Oregon Central Coast Forest Collaborative (OCCFC)

Wildlife ZOA Sub-group

Comment from USFS: Please note that stands to be treated and how to treat them has not been finalized for the proposed NF Smith River Project. We have identified current conditions and desired future conditions (DFC). We are seeking input to help us connect those points – what treatment, where, and when will get us to the DFC.

Figure 3. Riparian Reserves in the NF Smith Project Area

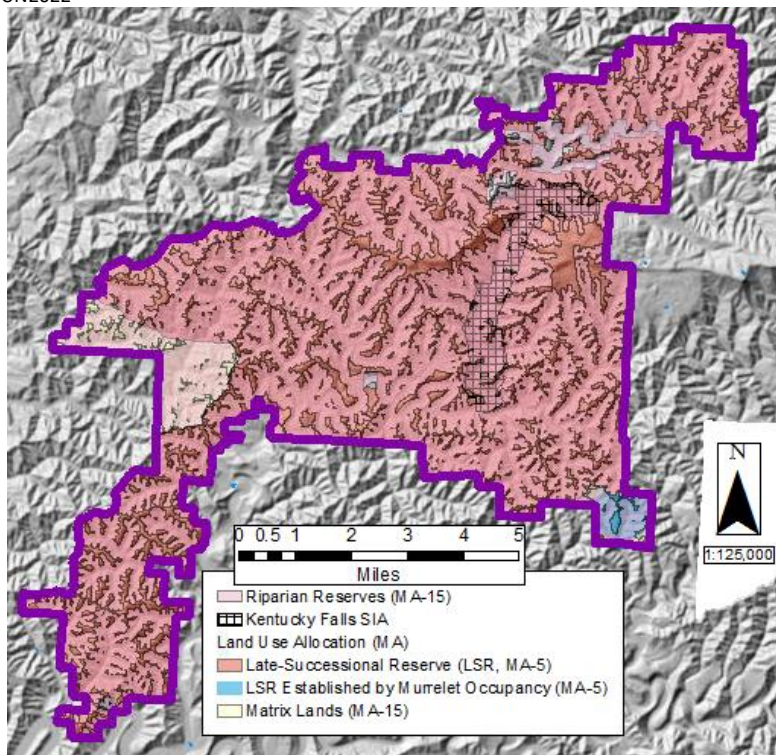
9 Is there currently thinning in the riparian buffer?

Thinning will be considered within the Riparian Reserve areas (Figure 3) as has been the case with past planning areas. Project design criteria (PDC) would be in place that would restrict restoration activities within specified stream buffers based on the stream class. Table 1 is an example from the Deadwood EA, Appendix A – PDCs that shows the outer, inner, and no equipment zones based on stream class. Within the inner zone for all stream classes, only non-commercial restoration is allowed. Please see Table 2 for associated design criteria from the Deadwood EA. The information in Table 1 and Table 2 that was included in the Deadwood EA are from the [Programmatic Vegetation and Aquatic Restoration Biological Opinion \(BO\); Endangered Species Act Section 7 and Magnuson-Stevens Act Consultation; Vegetation and Aquatic Restoration, September 20, 2019.](#)
